**ADDENDUM #5**

**T-20-122**

**FOR: Construction of a New Elevator and 2nd Floor AODA Washroom**

ELECTRICAL ADDENDUM NO. E-002 R1

E100

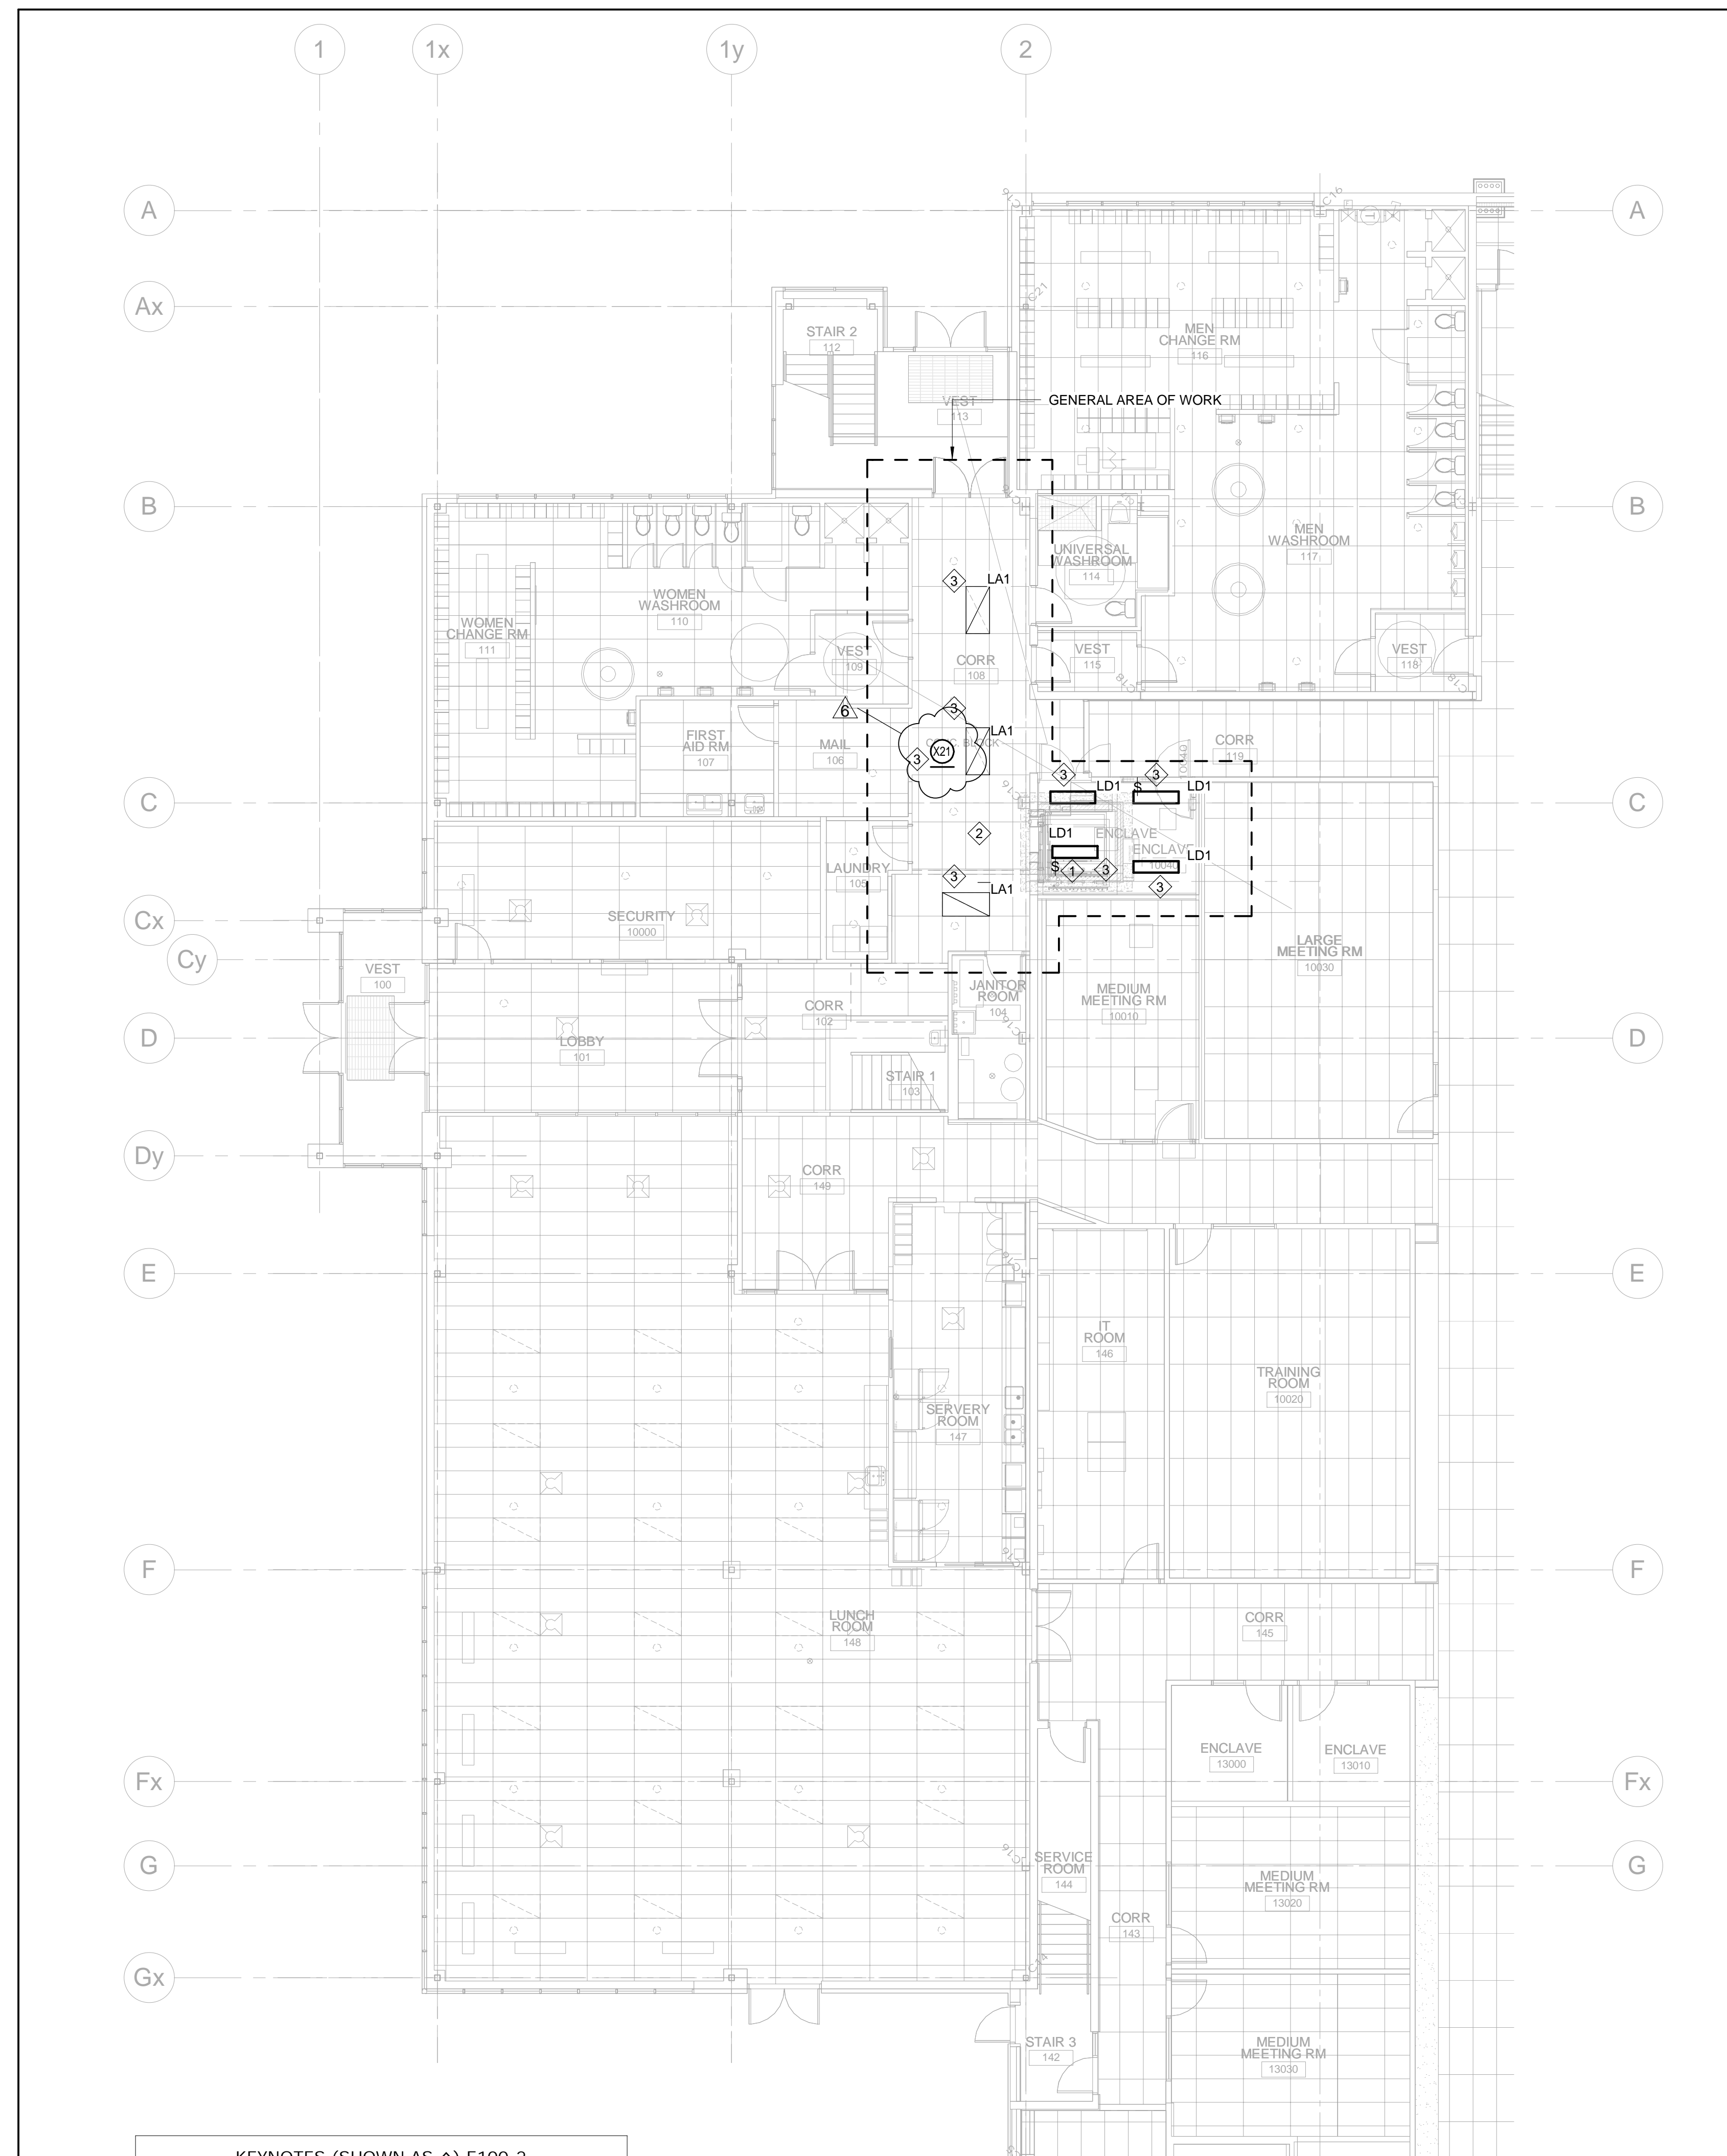
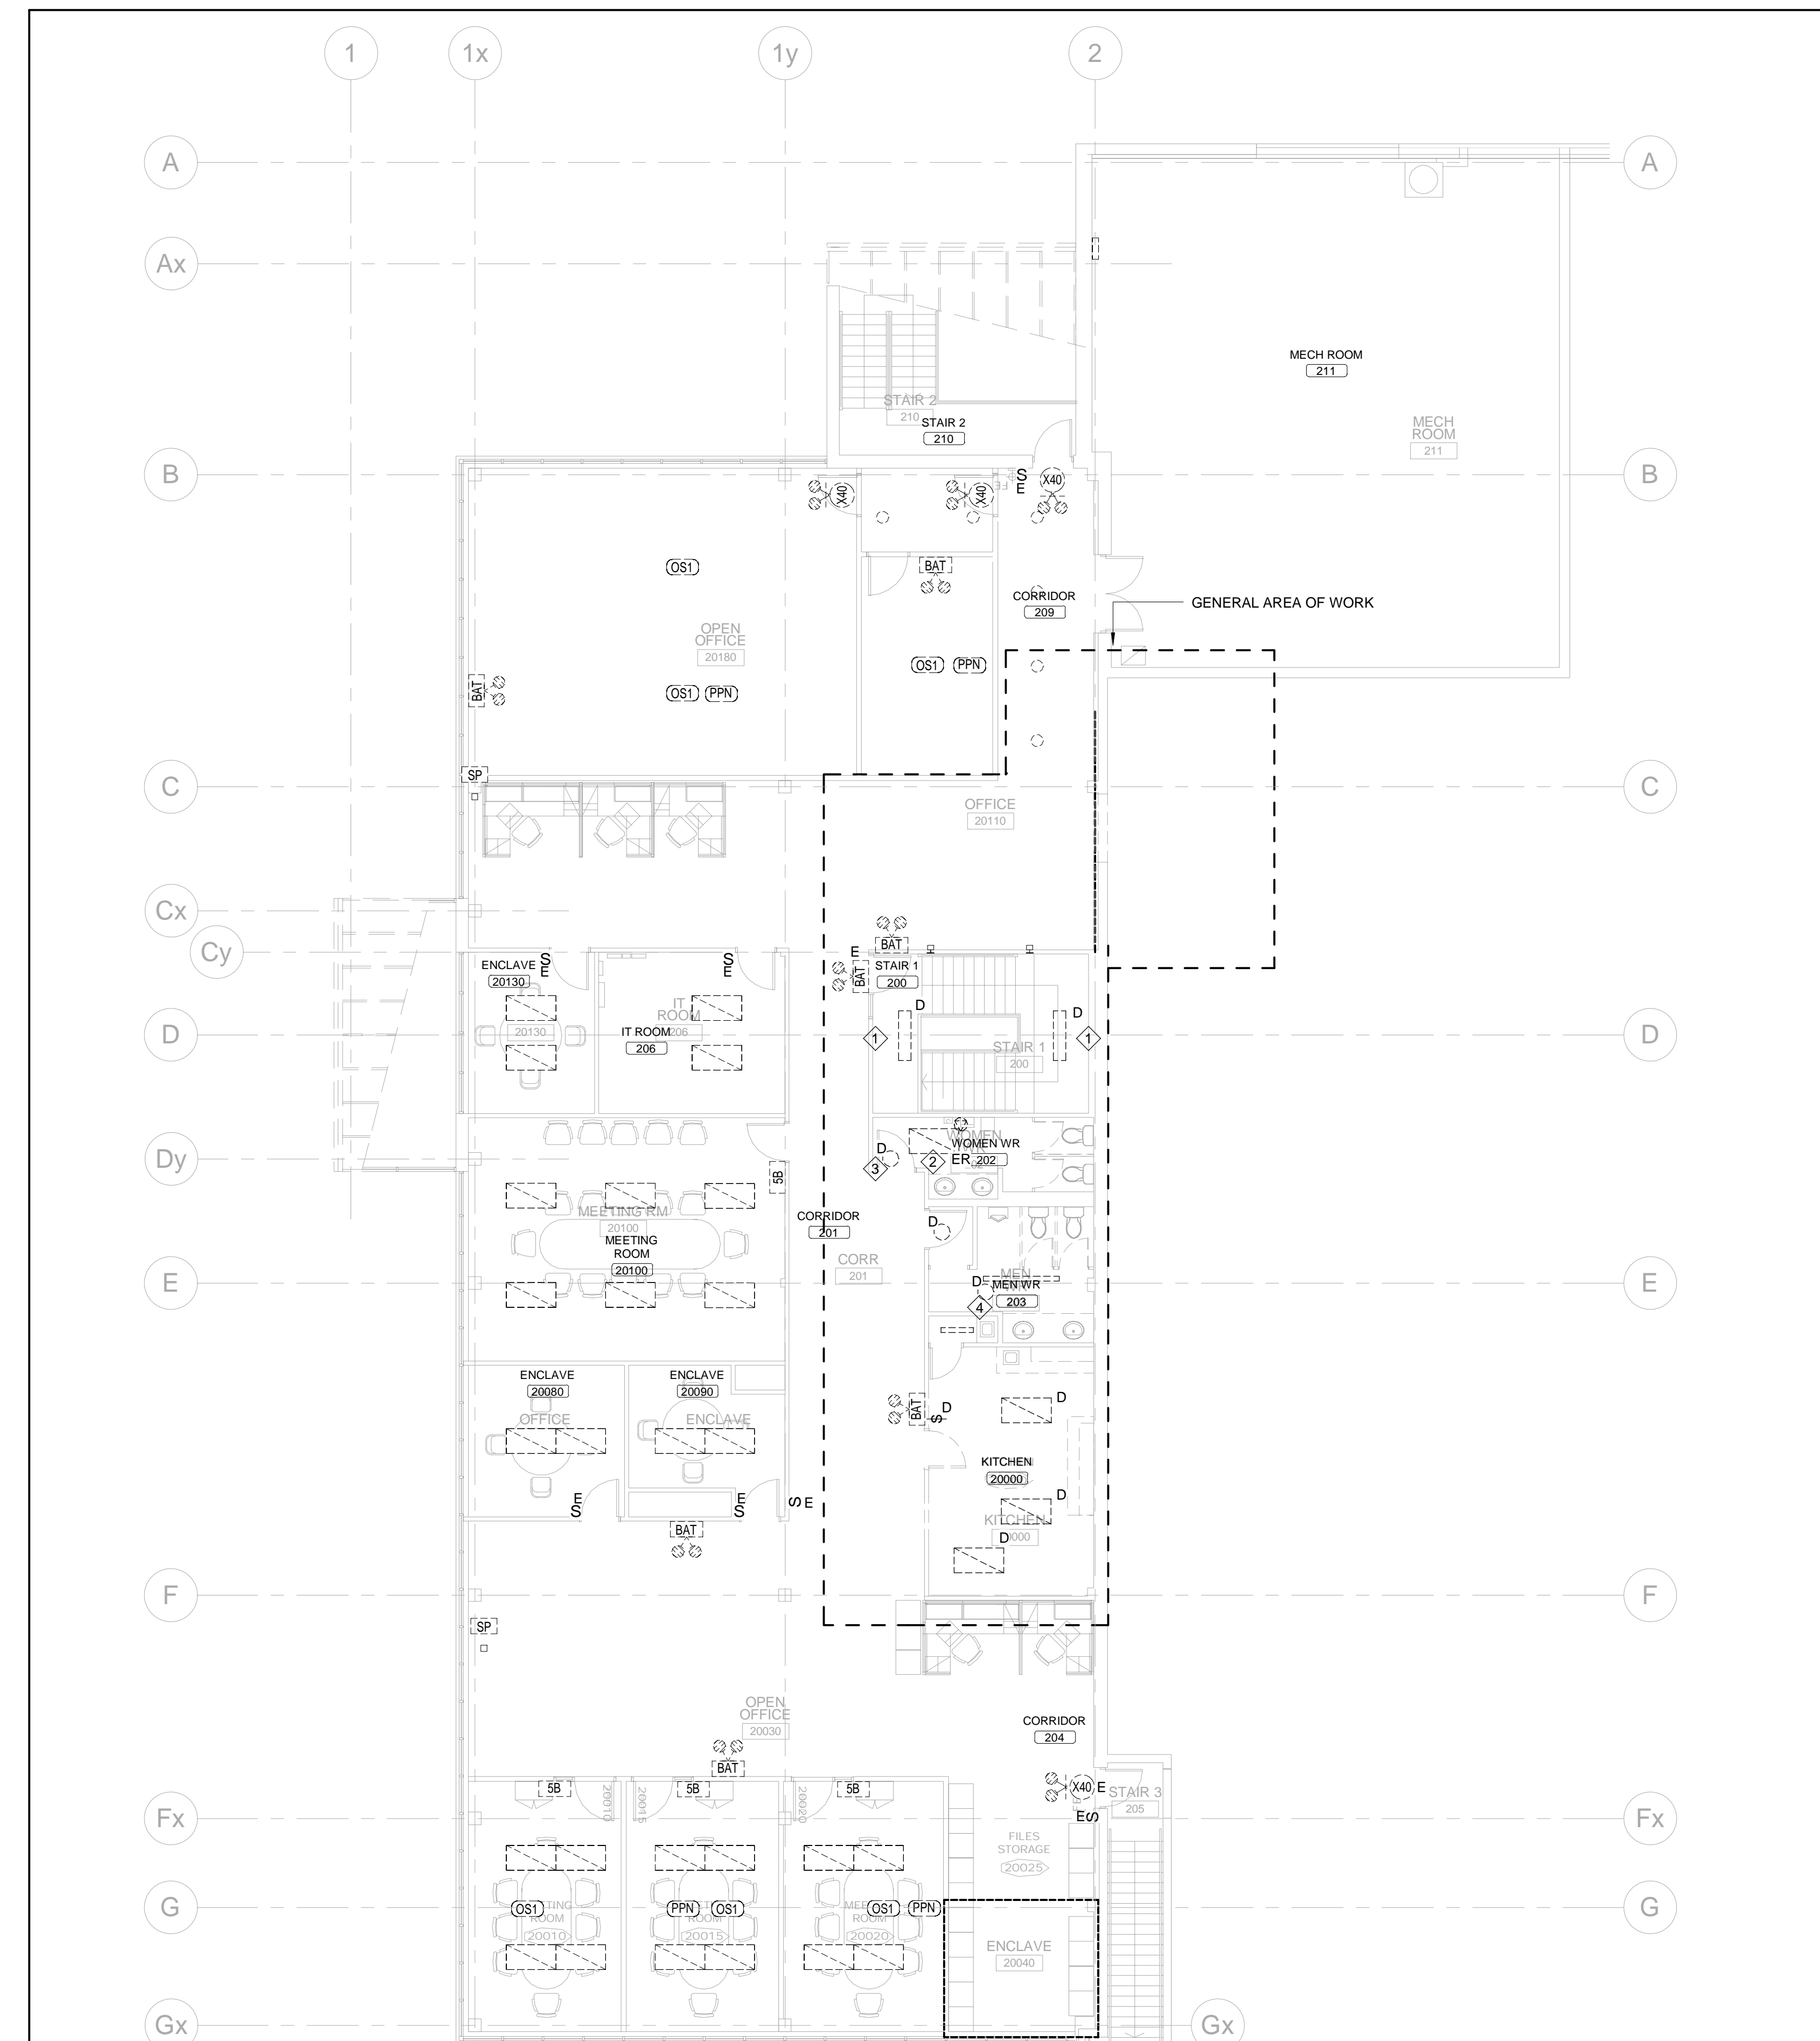
- a. Drawing E001 – Electrical legend, notes and Lighting fixtures schedule
  1. Lighting fixture schedule has been updated.
- b. Drawing E100 – Ground Floor-Lighting layout
  1. Exit sign types have been revised.
- c. Drawing E101 – Second Floor-Lighting layout
  1. Exit sign type X11 has been deleted.
  2. General notes have been revised.
- d. Drawing E200 – Ground floor-Power and Systems layout
  1. Circuits have been revised.
  2. Type of data drop located on the west wall of Enclave room 10049 has been revised.
  3. Breaker and Feeder sizes for hydraulic elevator have been specified.
  4. Keynotes have been revised.

- 1.1 E001 – Electrical legend, notes and Lighting fixtures schedule
  - 1.1.1 Lighting fixture schedule has been updated.
- 1.2 E100 – Ground floor-Lighting layout
  - 1.2.1 Exit sign types have been revised.
- 1.3 E101 – Second floor-Lighting layout
  - 1.3.1 Exit sign type X11 has been deleted.
  - 1.3.2 General notes have been revised.
- 1.4 E200 – Ground floor-Power and Systems layout
  - 1.4.1 Circuits have been revised.
  - 1.4.2 Type of data drop located on the west wall of Enclave room 10049 has been revised.
  - 1.4.3 Breaker and Feeder sizes for hydraulic elevator have been specified.
  - 1.4.4 Keynotes have been revised.
